RE: **IN THE MATTER OF THE REQUESTS FOR RECONSIDERATION
FILED BY MURPHY DESHONG CONCERNING THE APPLICATION
BY LOVE'S TRAVEL STOPS & COUNTRY STORES, INC. FOR THE
AMENDMENT AND RENEWAL OF PERMIT NO. WQ0015618001
TCEQ DOCKET NO. 2024-0665-MWD**

**OFFICE OF PUBLIC INTEREST COUNSEL’S RESPONSE TO
REQUESTS FOR RECONSIDERATION**

ATTACHMENT B

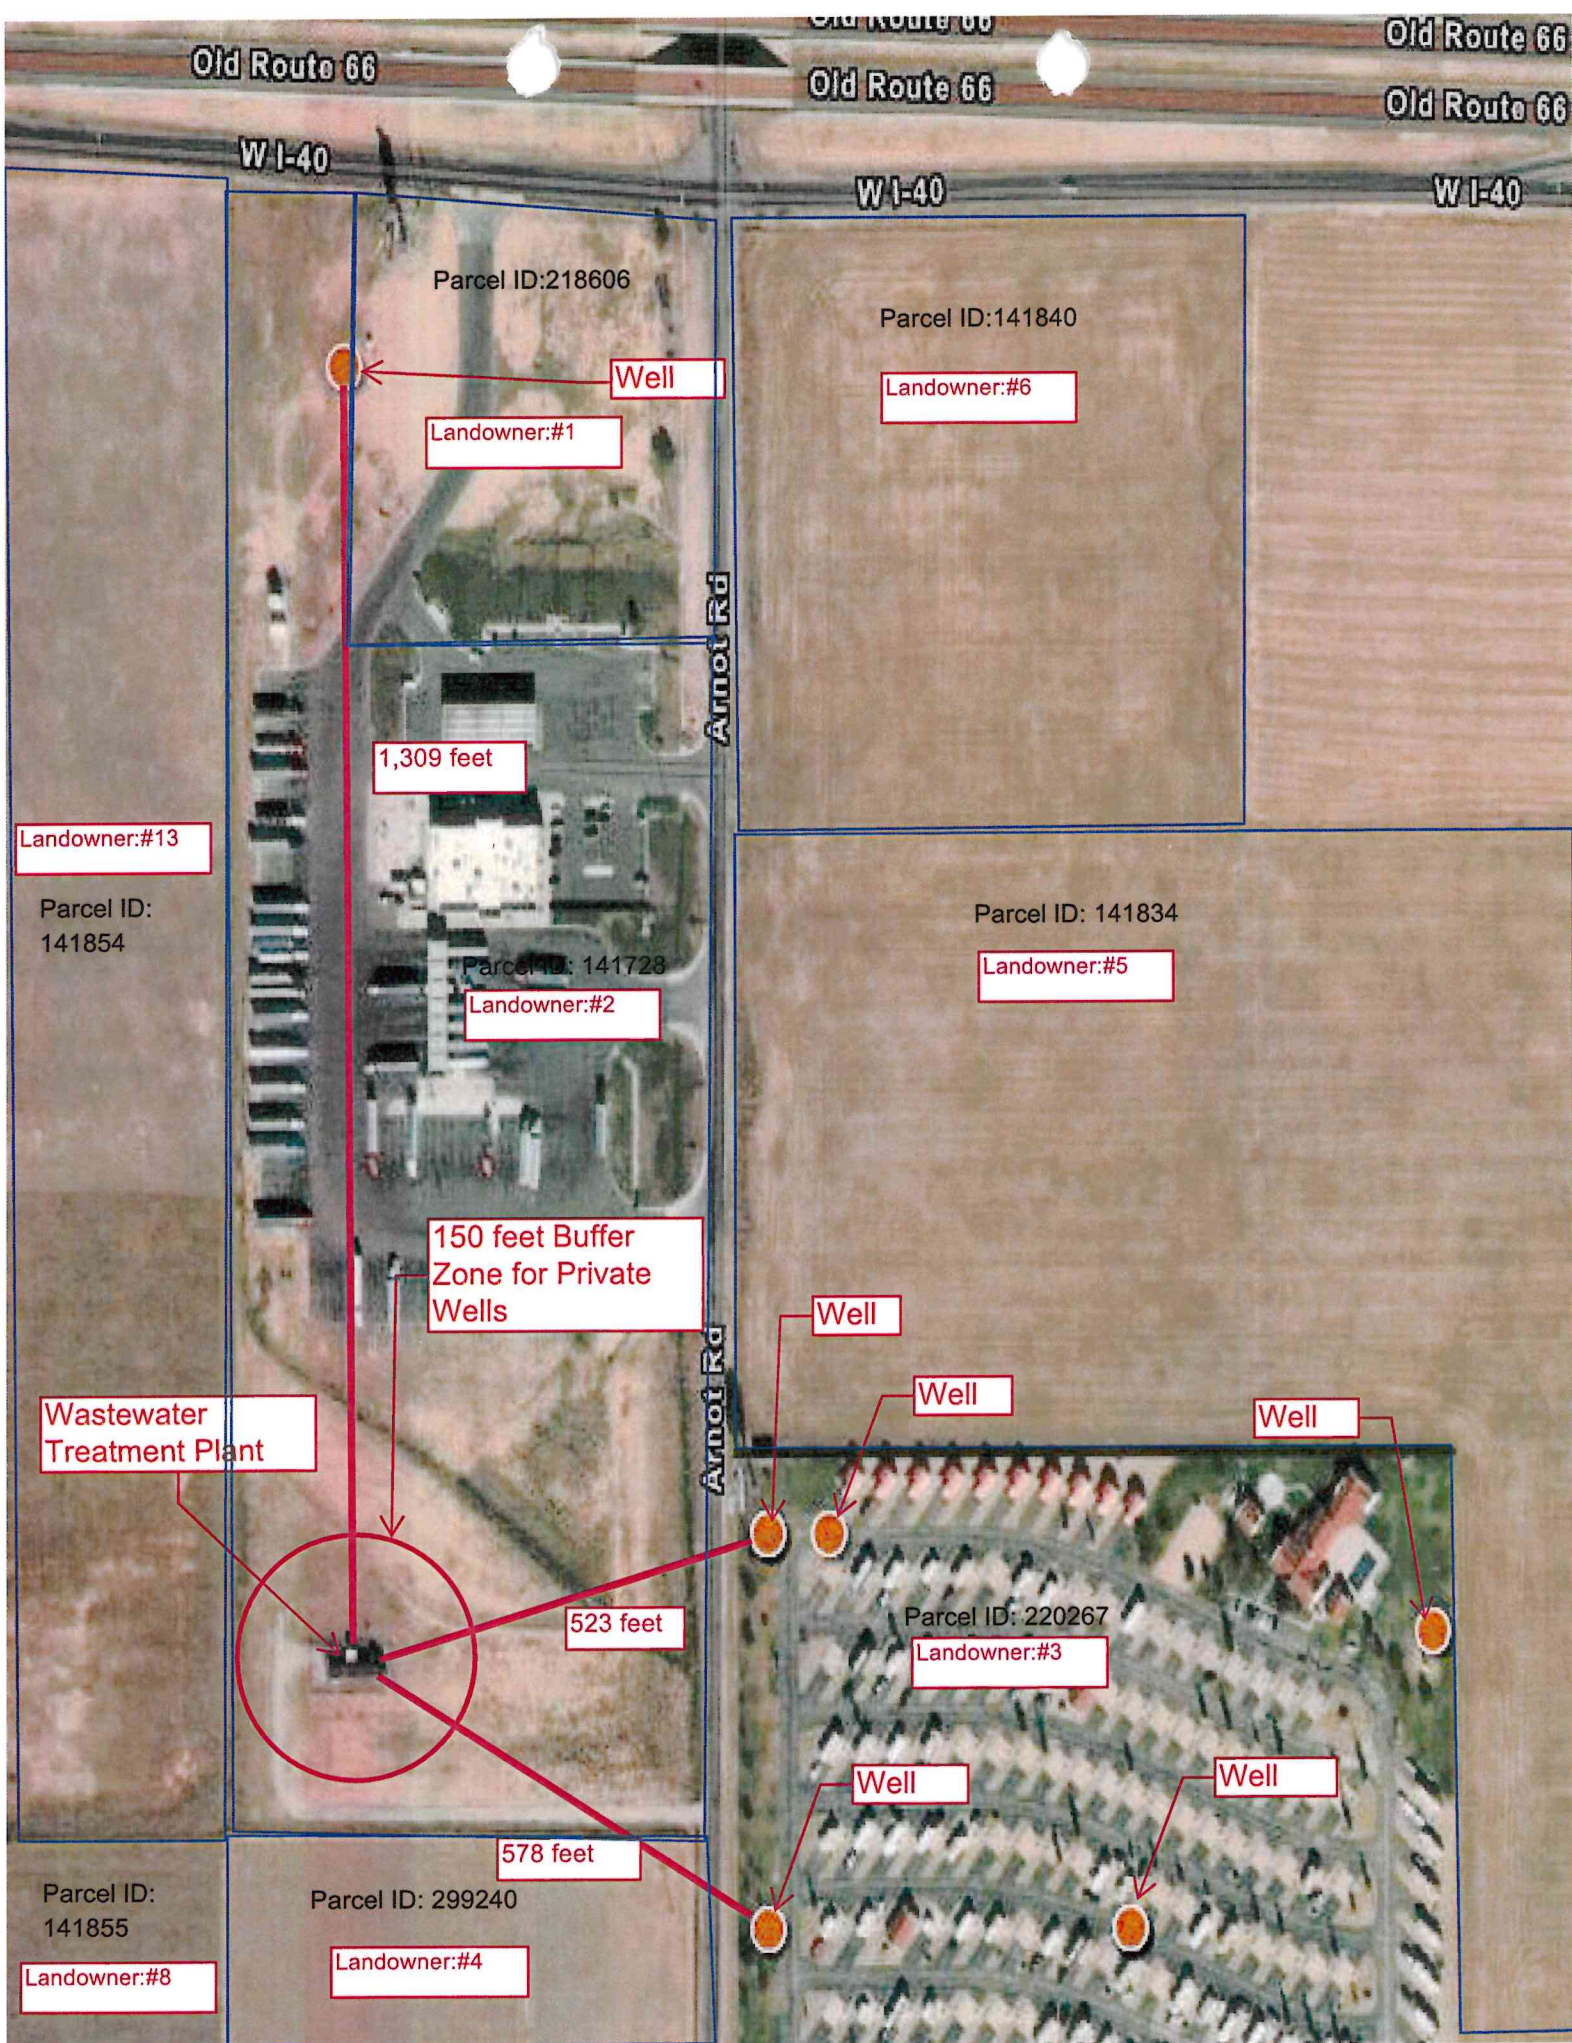
Included with the application materials are two aerial maps, both attached for reference. One map purports to show compliance, i.e. that the buffer zone is met in all directions.¹³ However, the other map shows that the Facility is only 125 feet from the western property line.¹⁴ This map depicts the treatment plant as a whole and does not indicate the positions of individual treatment units relative

ATTACHMENT C

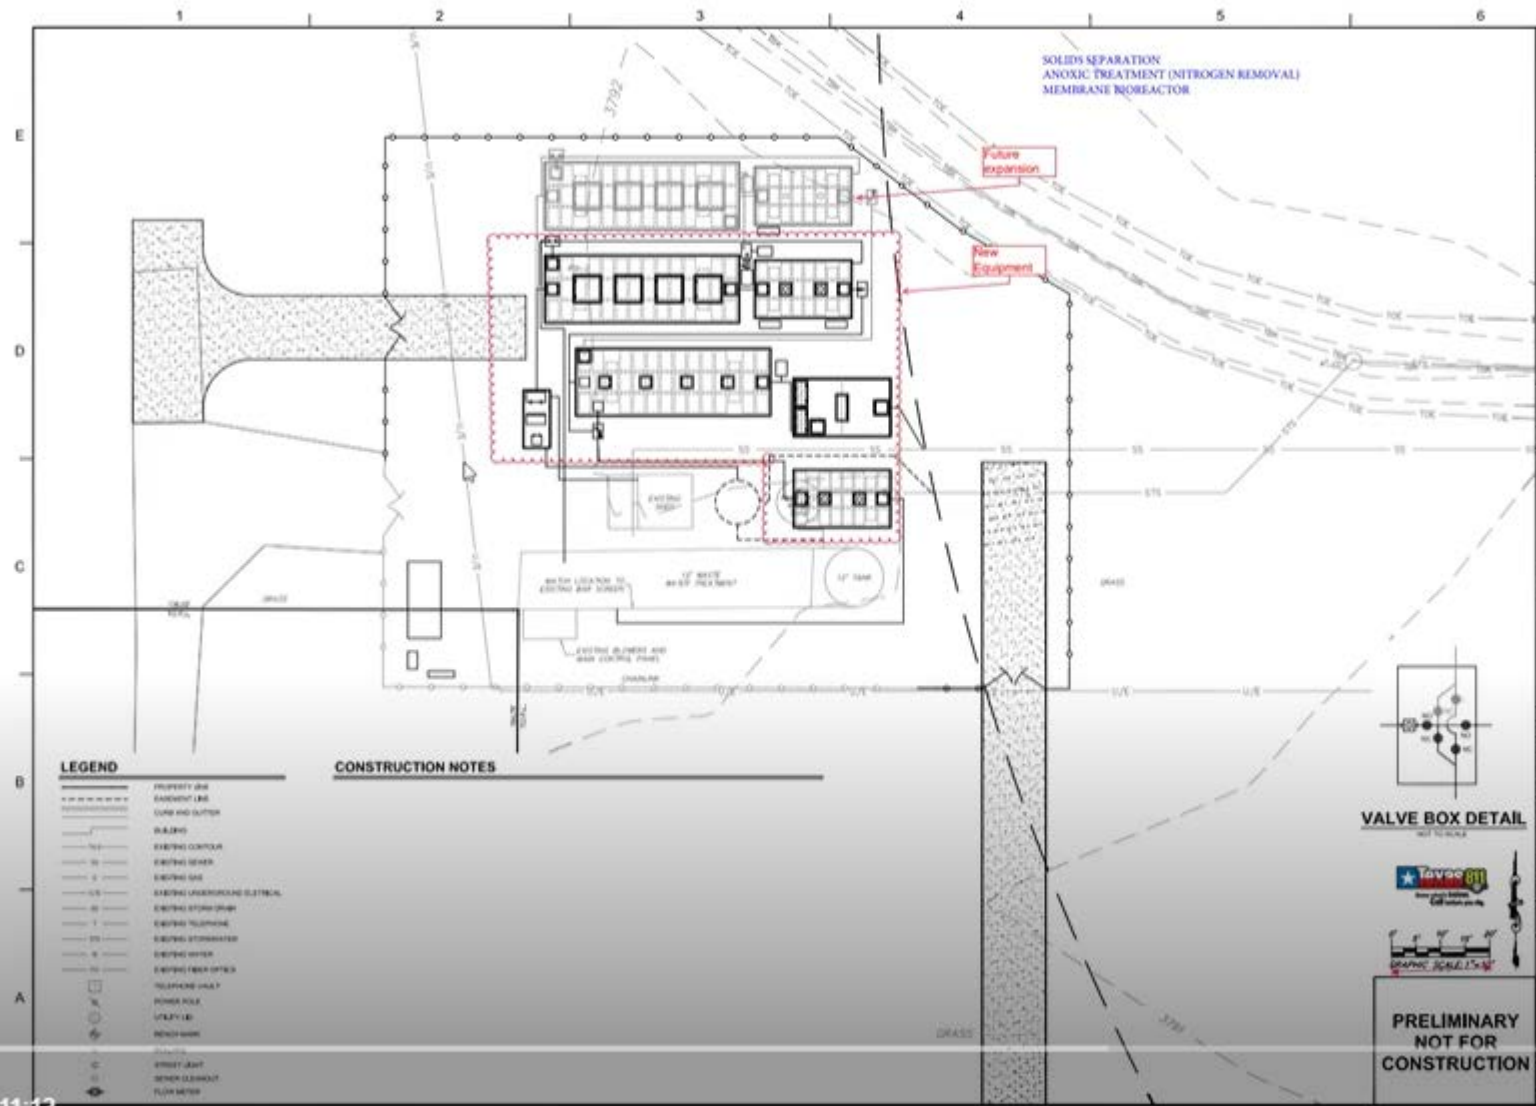
to property boundaries. As such, it is unclear whether the 125-foot distance shown on the map encompasses the entire plant or merely a portion of it. Consequently, OPIC is unable to conclude if the treatment units themselves are able to meet the 150-foot distance requirement. Given the conflicting information contained in the application materials, OPIC finds that the application does not demonstrate compliance with the buffer zone requirements.

ATTACHMENT D

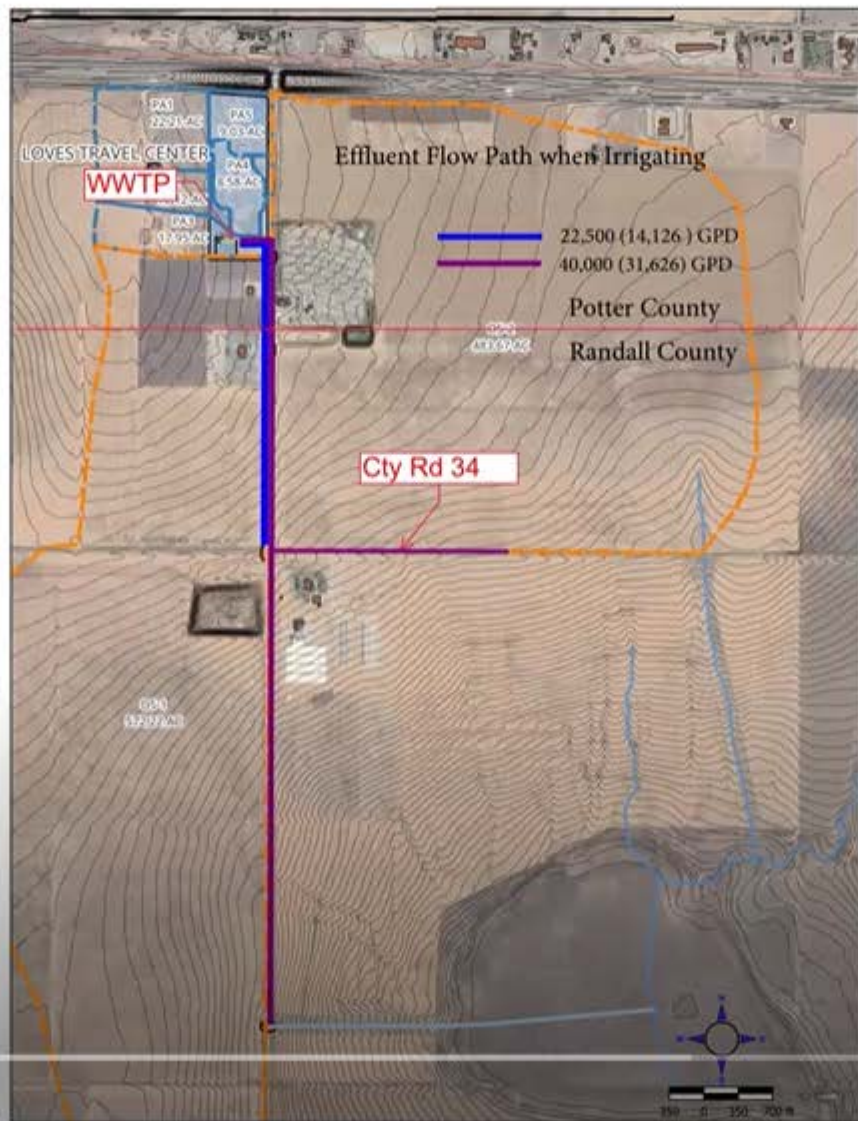
Additionally, OPIC acknowledges that requestor references a layout shown during a recent Randall County Commissioners Court meeting. Mr. DeShong argues that it shows the Facility is 136 feet from the western property line instead of the required 150 feet. Mr. DeShong did not include the layout as an exhibit to his request. While OPIC was able to locate and view the Commissioners Court meeting for this item online, meeting documents were not available for download. OPIC took screenshots of both graphics presented by the Applicant and includes them here for completeness of the record.¹⁵ However, after examination, OPIC is unable to conclude that either of these two graphics demonstrate that the buffer zone is inadequate. Nonetheless, OPIC finds that the application materials themselves evince that the buffer zone will not be complied with.

To be clear, OPIC is not certain that either of these documents is the layout referenced by Mr. DeShong. Should he choose to file one, OPIC invites Mr.
